NEW TERRITORIES MASTER PLAN

PRELIMINARY OVERALL AREA DEVELOPMENT PLAN

RE: New Territories POADP #187

RE: New Territories P.O.A.D.P. (Revised August 26, 1985)
(File #83-10-61-60)

NEW TERRITORIES MASTER PLAN

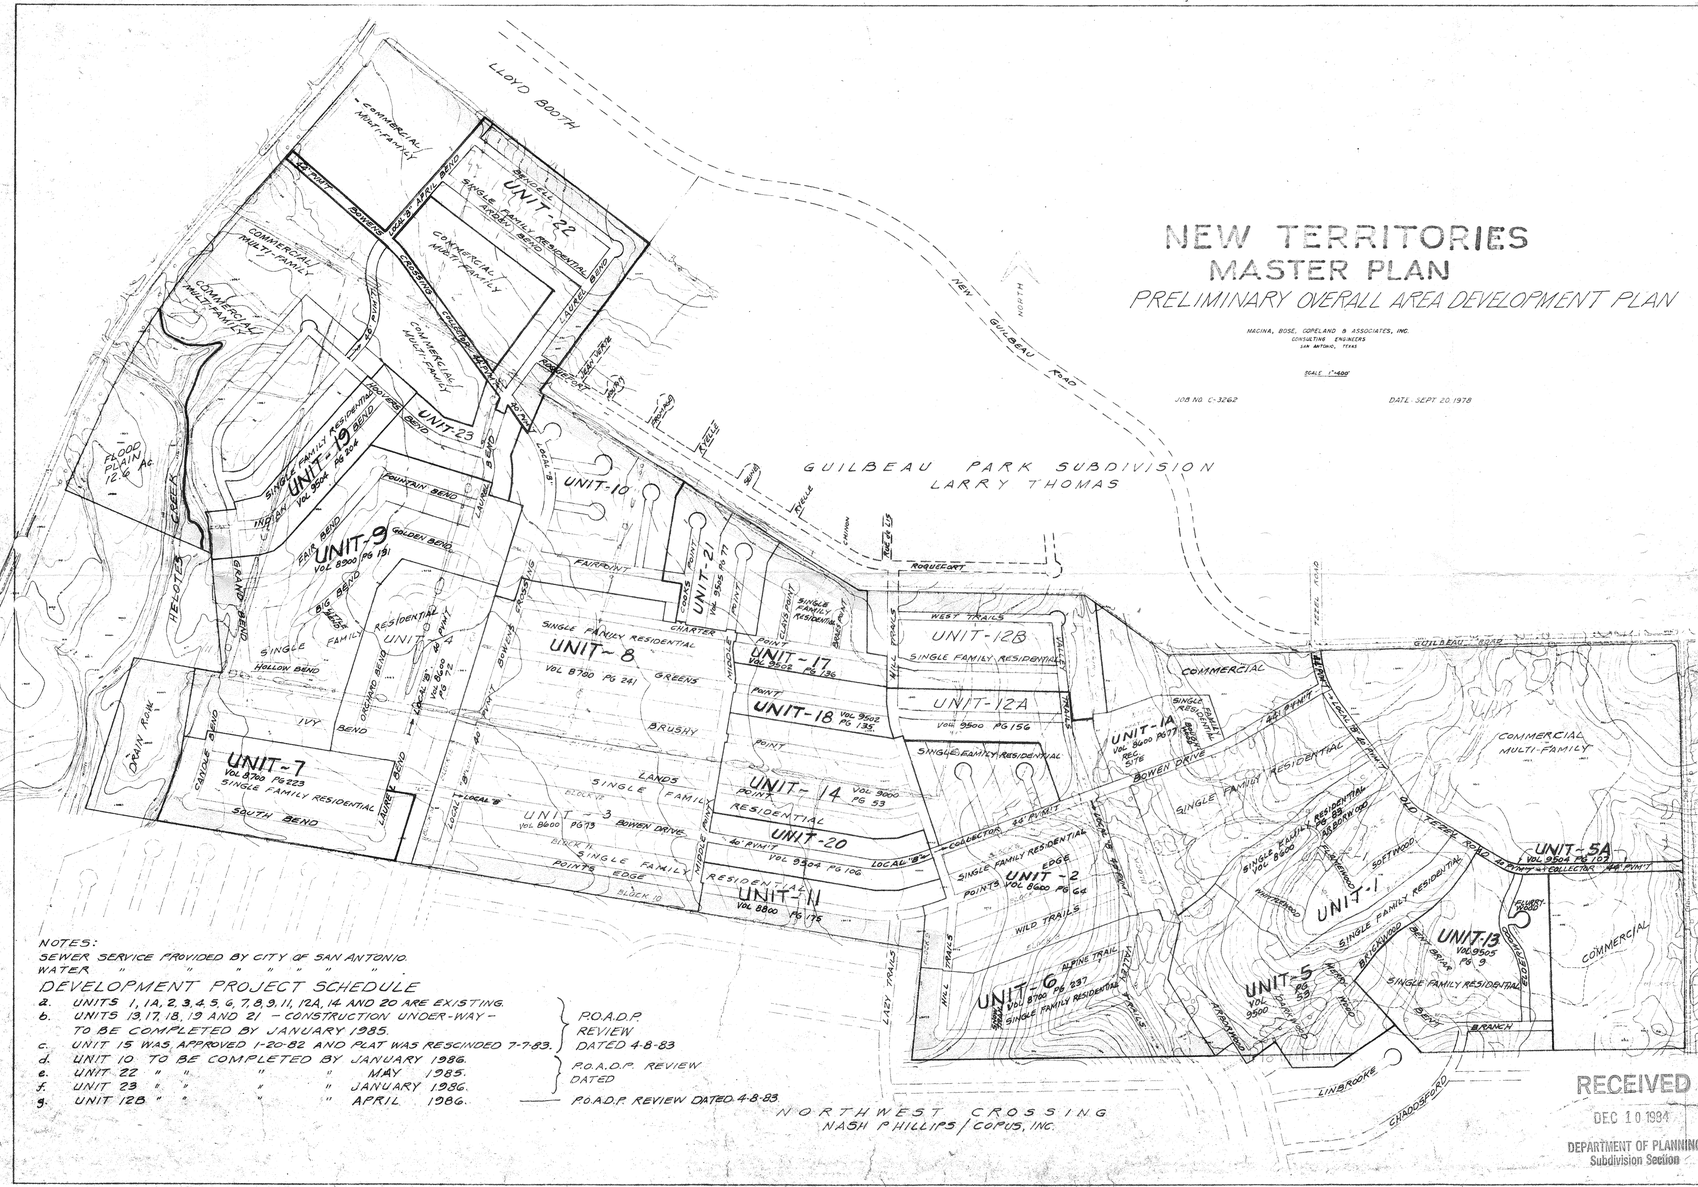
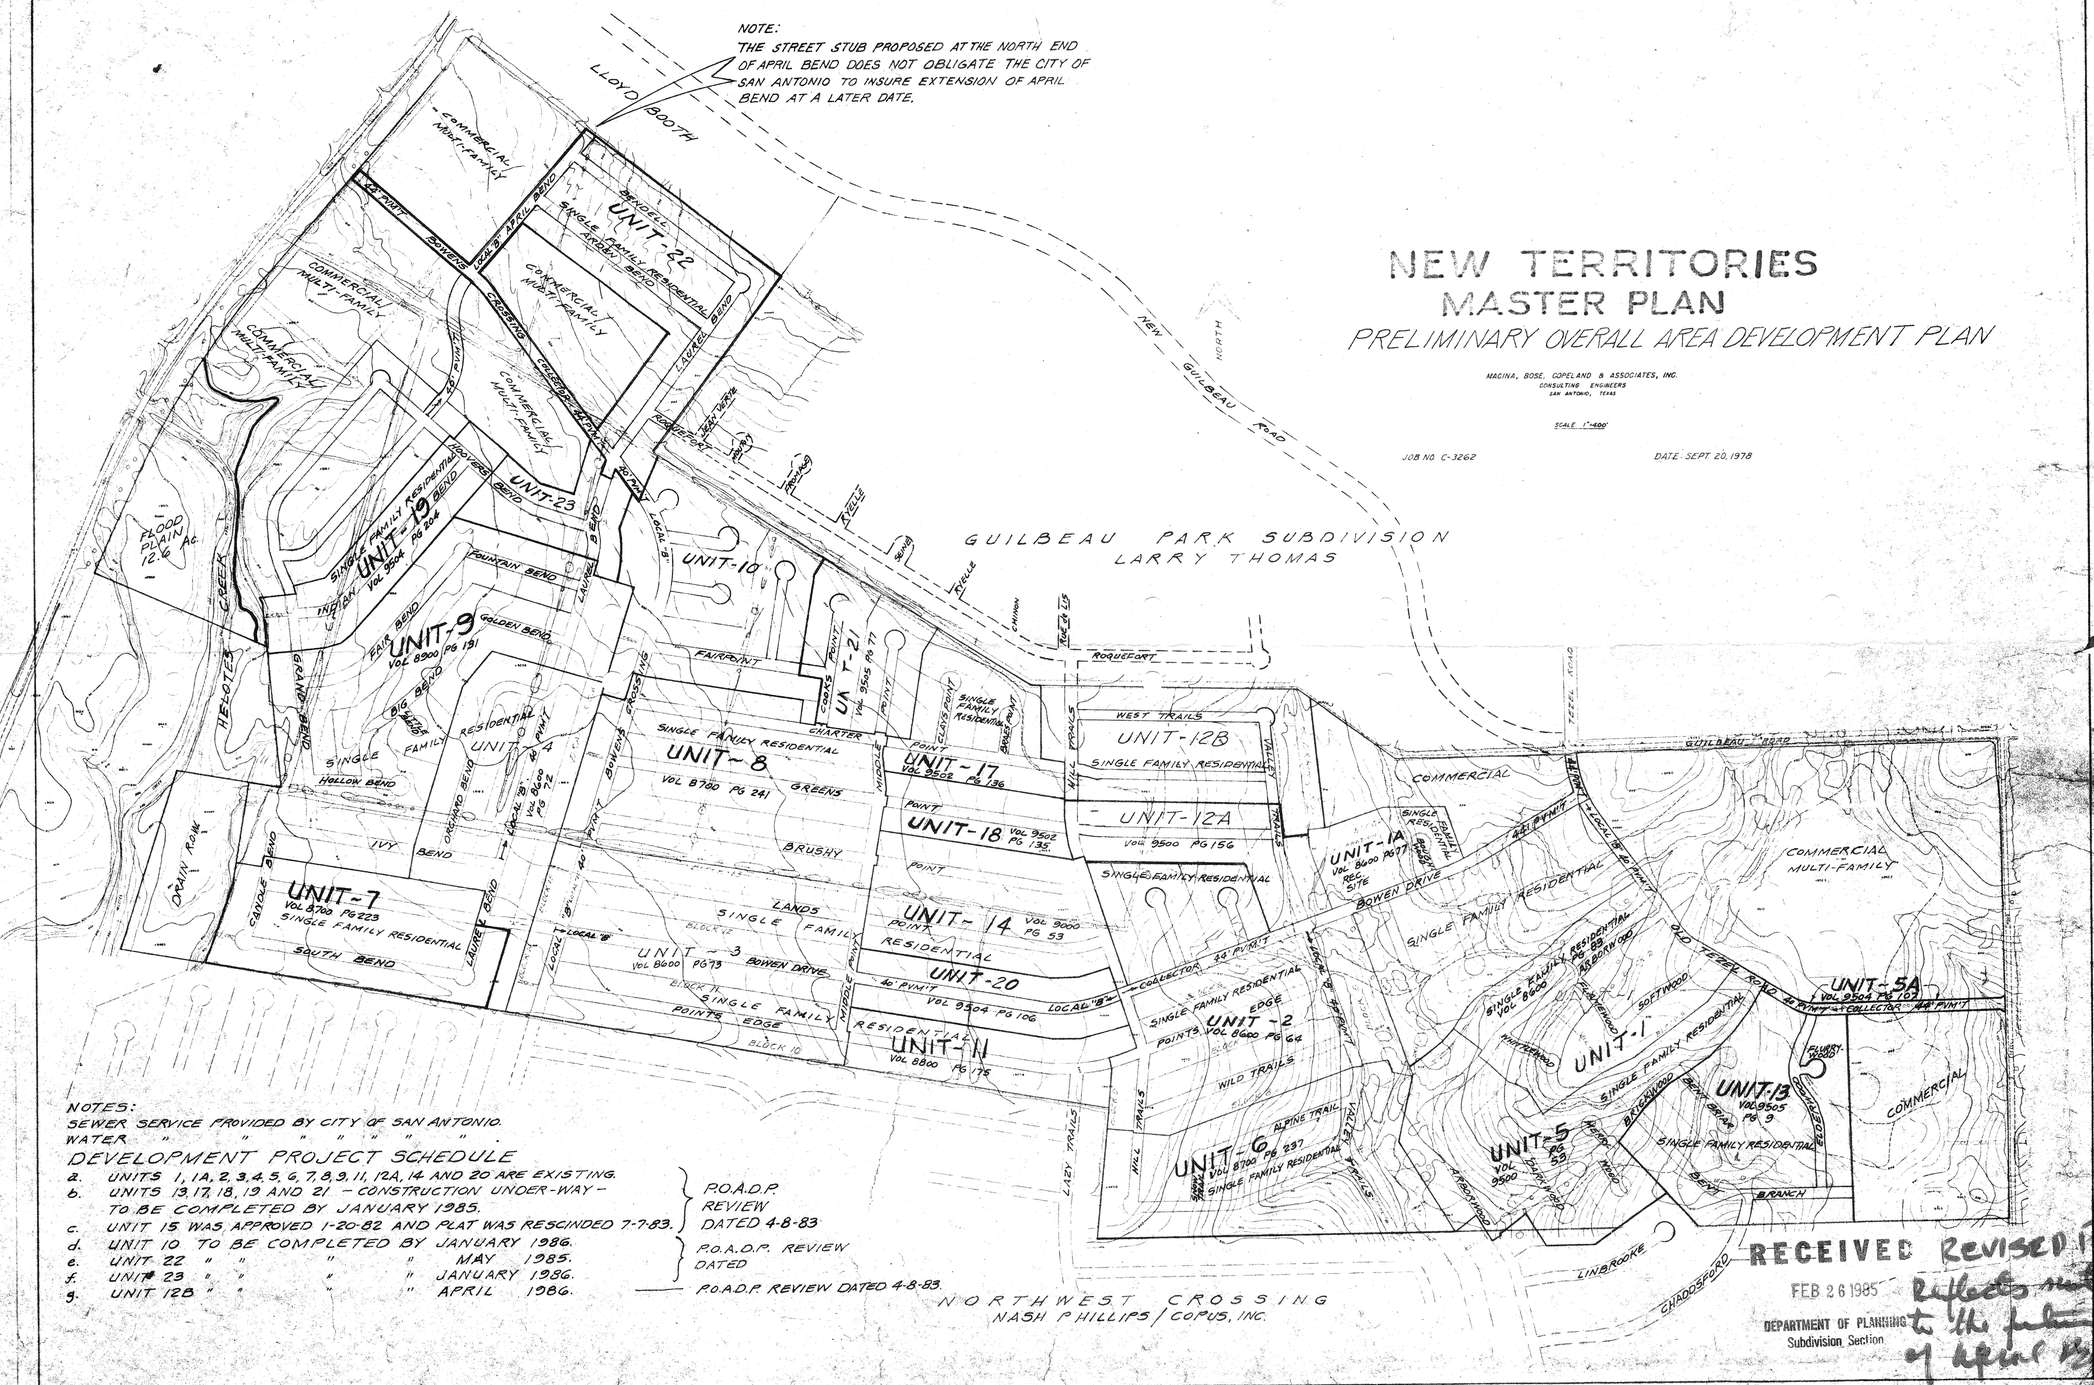
Reflects note relating to the future extension of April Bend.

(XX) Comments: This acknowledges receipt of the amended plan reflecting an annotation pertaining to the April Bend stub street as per our meeting of February 22, 1985. Please be advised that staff offers no objection to the revision.

NOTE:
THE STREET STUB PROPOSED AT THE NORTH END OF APRIL BEND DOES NOT OBLIGATE THE CITY OF SAN ANTONIO TO INSURE EXTENSION OF APRIL BEND AT A LATER DATE.

NOTE:
THE STREET STUB PROPOSED AT THE NORTH END OF APRIL BEND DOES NOT OBLIGATE THE CITY OF SAN ANTONIO TO INSURE EXTENSION OF APRIL BEND AT A LATER DATE.

NEW TERRITORIES
MASTER PLAN
MAP # 187

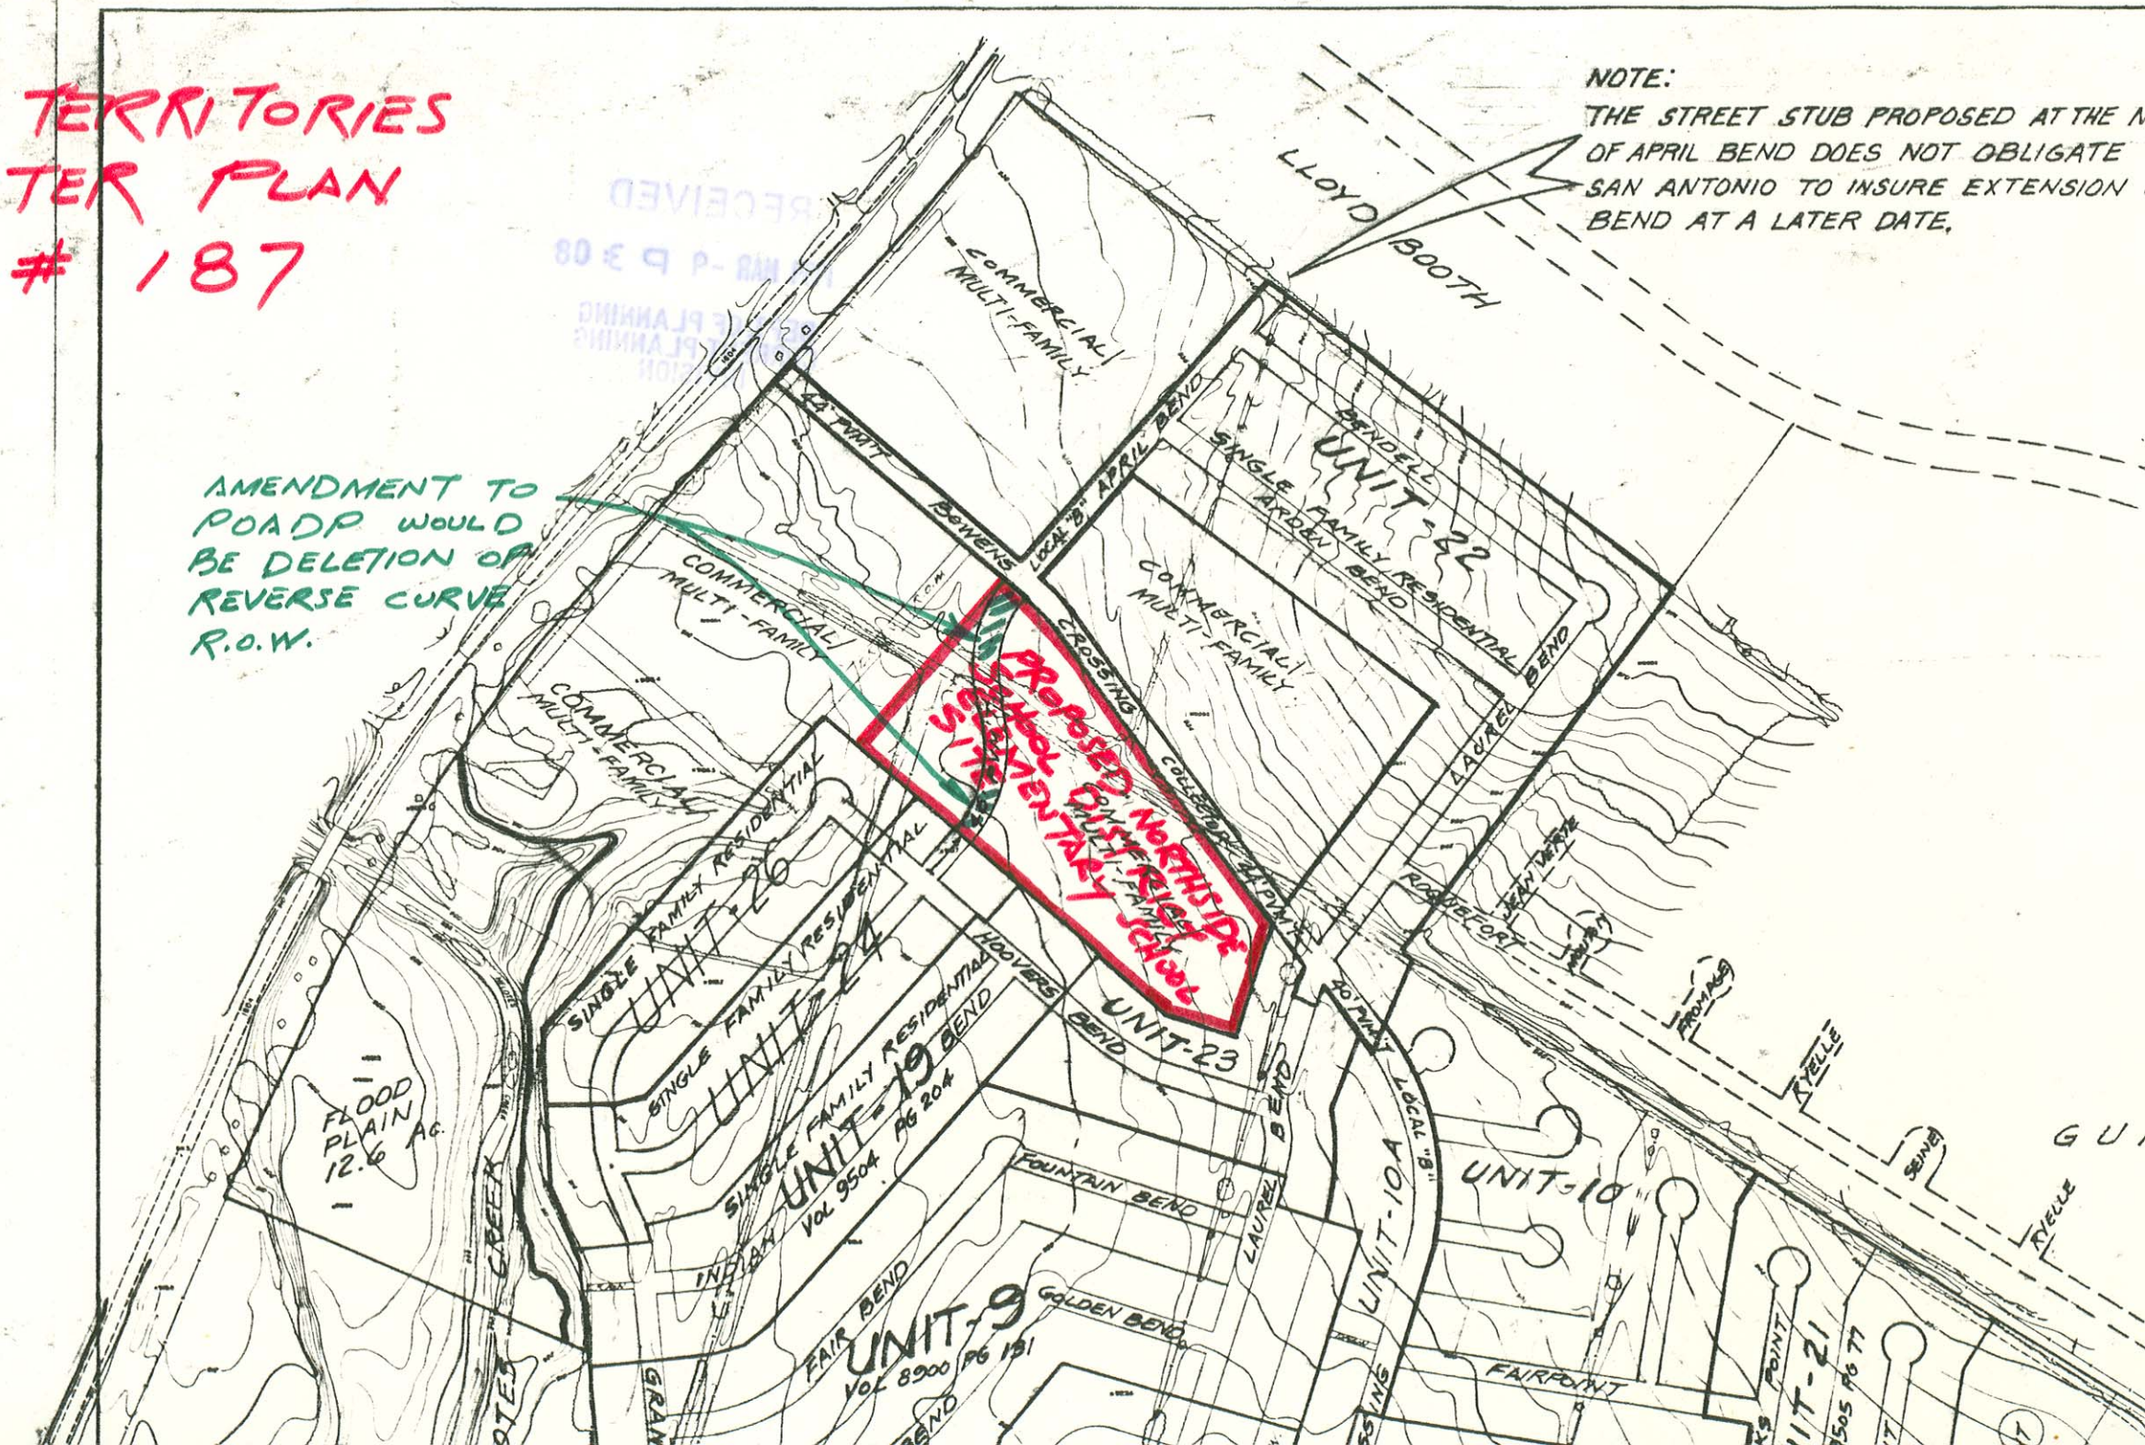
ROY: I AM REQUESTING A PRELIMINARY REVIEW FROM YOU ON THE DELETION OF THE PROPOSED REVERSE CURVE RIGHT-OF-WAY AS SHOWN ON THE ATTACHED SKETCH. A POSITIVE RESPONSE WOULD BE HELPFUL TO US BEFORE MAKING A CHANGE TO OUR P.O.A.D.P. AND MAKING A REVISED FORMAL SUBMITTAL TO YOUR DEPT.

Paul De Leon will revise POADP plan. The committee reviewed this sketch on 3/10/89. They offered no objections to the removal of the street. Mr. DeLeon was notified on 3/15/89. Roy
